Town of Brookfield
645 N. Janacek Road
Brookfield, WI 53045
(P) 262-796-3788
(F) 262-796-0339

PLAN COMMISSION

AGENDA

RE: **Discount Tire – Site Plan Review**
20120 W Bluemound Rd BKFT1123999001

PROPOSED SITE PLAN

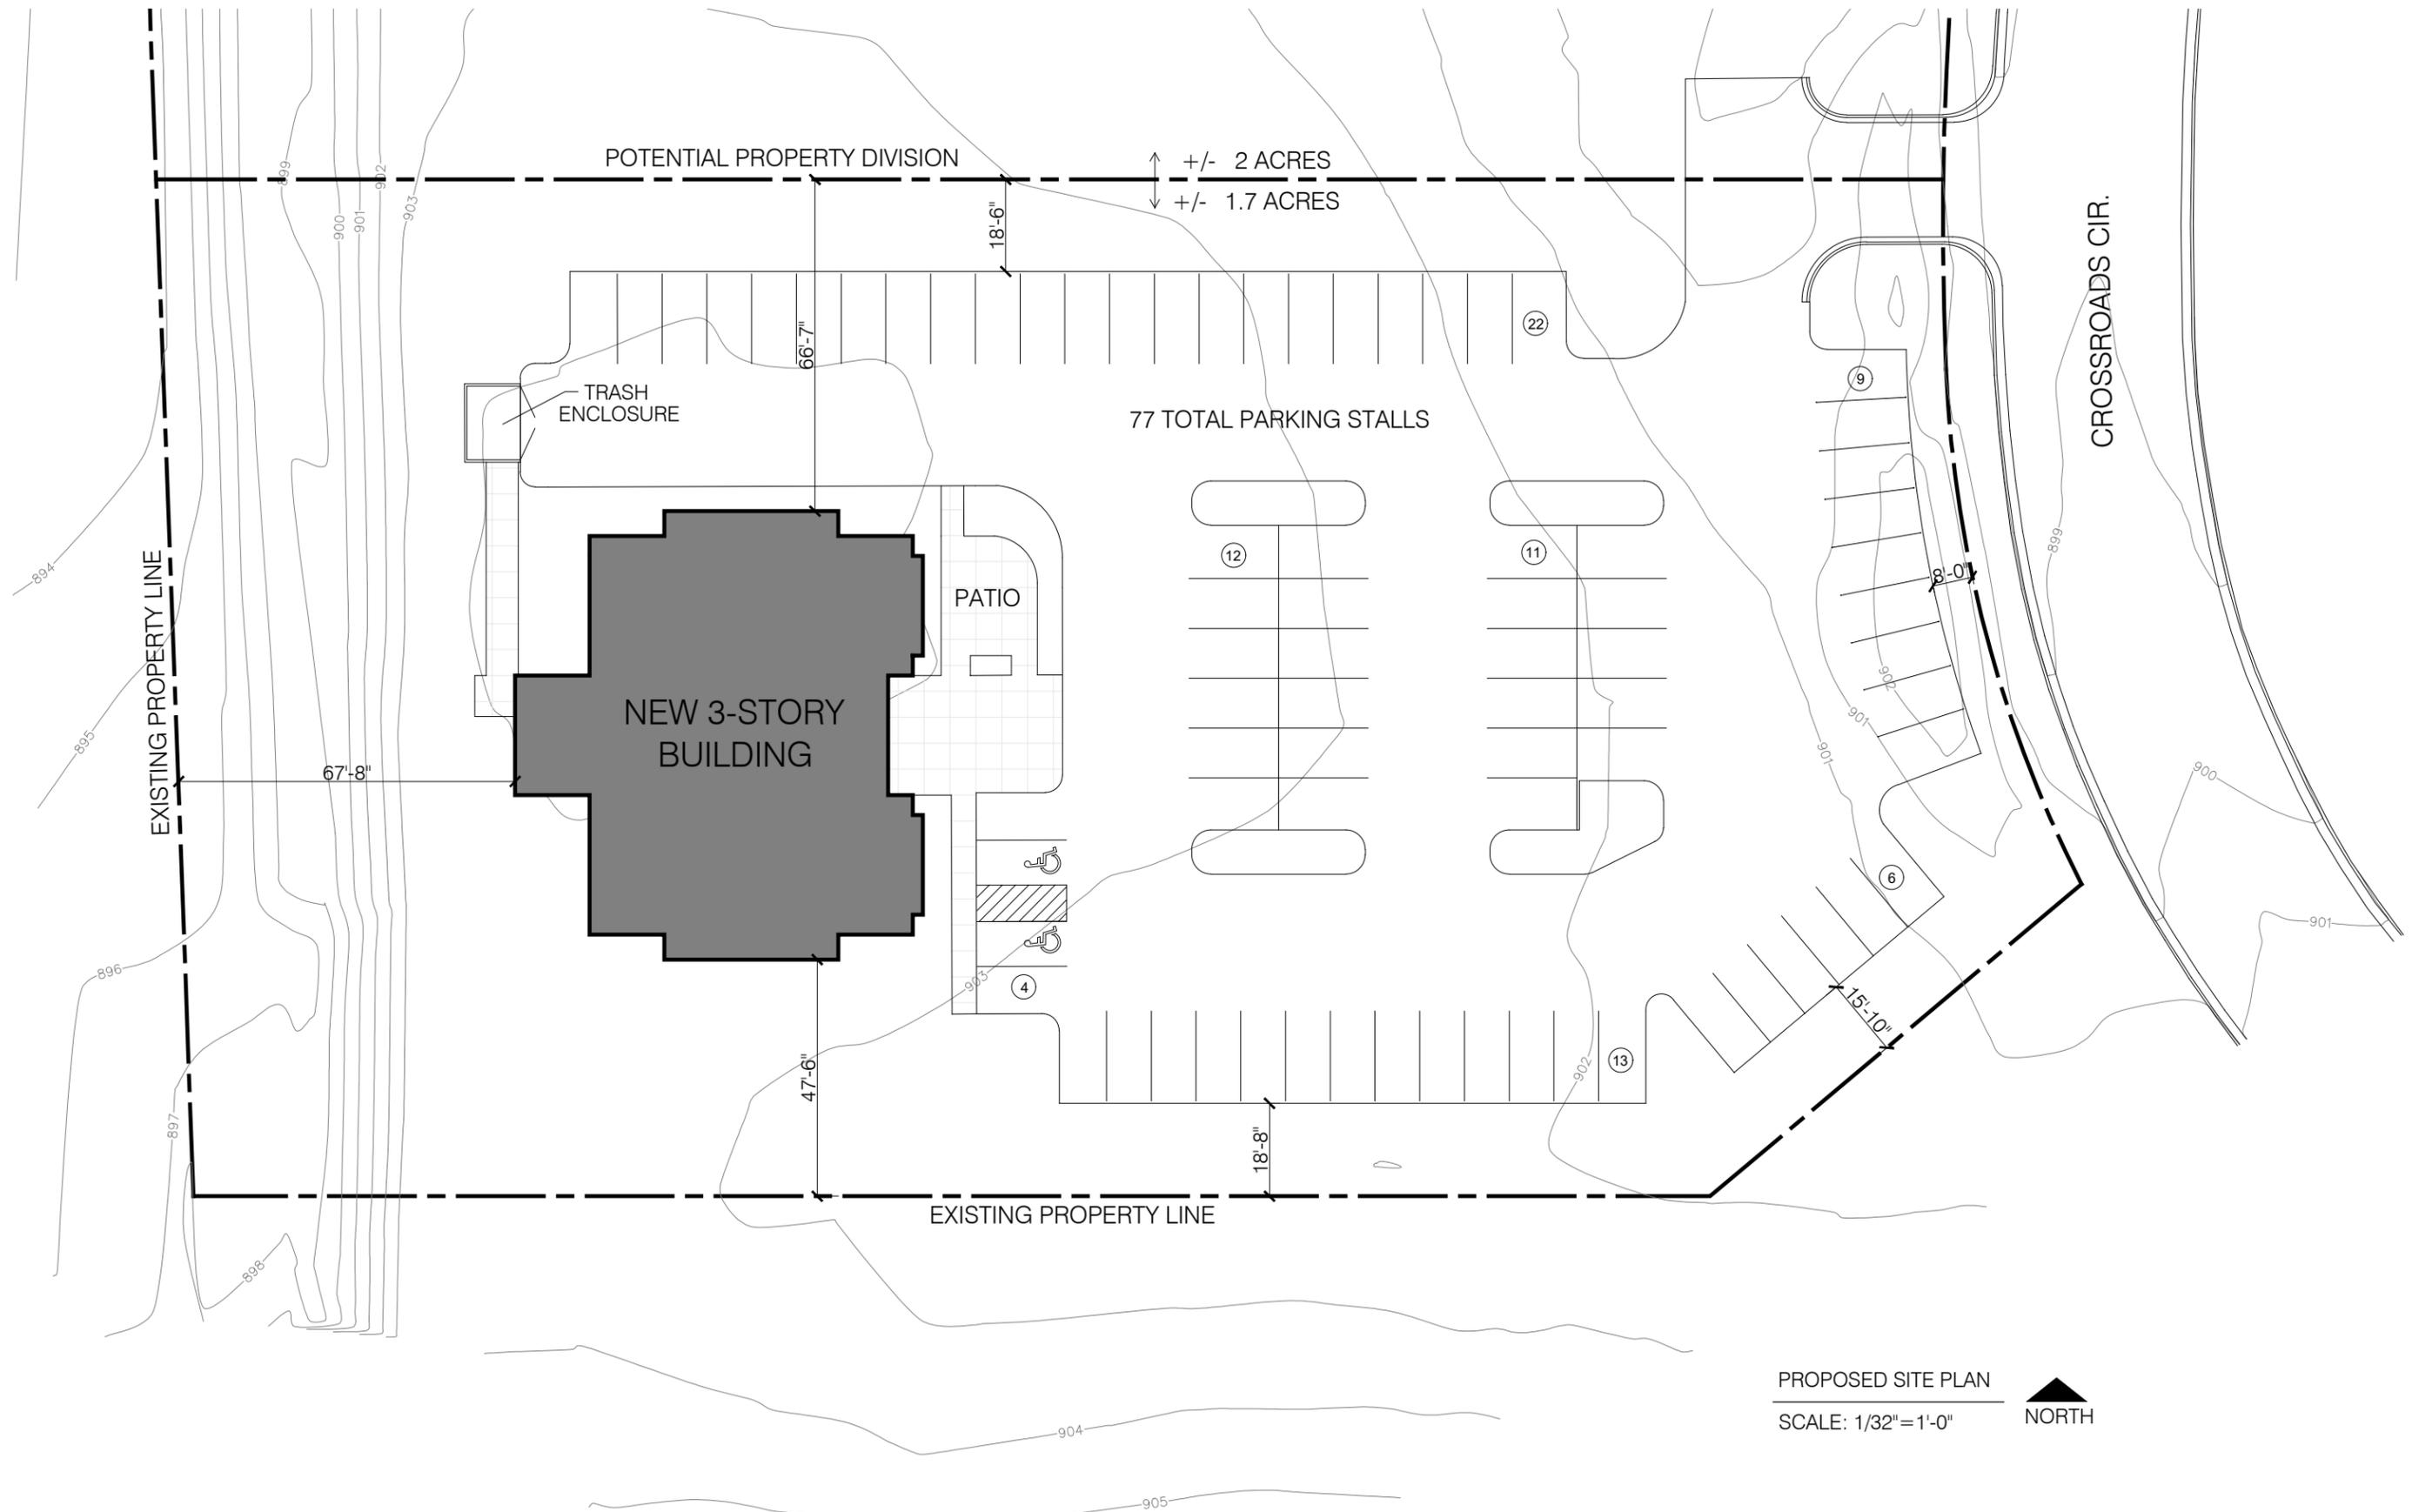
- According to the code, 88 parking spaces are required for the square footage and the number of employees is unknown at this time.
 - The proposed site plan shows a drive access connection to the future lot to the north.

- Rear = 67'
- All building setbacks will meet code requirements.
- The pavement setback along the Crossroads Circle right-of-way appears to not meet the 10' requirement (8' is proposed).
- Sum total of floor area
 - Proposed = 23.79% of lot area.
 - Required = No less than 6,000sf or 15% of the lot area, whichever is less. Shall not exceed 50% of lot area.
 - Requirement is met.
- No building height dimensions were provided but the building will likely meet the 45' height requirement.
- There are single-family residences directly to the west of the subject property, but only one of the adjacent parcels is zoned residential. The applicant intends to keep the existing landscaping to serve as a buffer for the residential properties.

The development review team has provided some initial feedback regarding the plans, but most of the comments or concerns can be addressed later in the review process. The purpose of conceptual project review shall be to determine the best use of a building site. The Plan Commission will consider the proposed land use and its compatibility with adjacent land uses. The Plan Commission should consider ingress and egress, off-street parking, and internal traffic patterns.
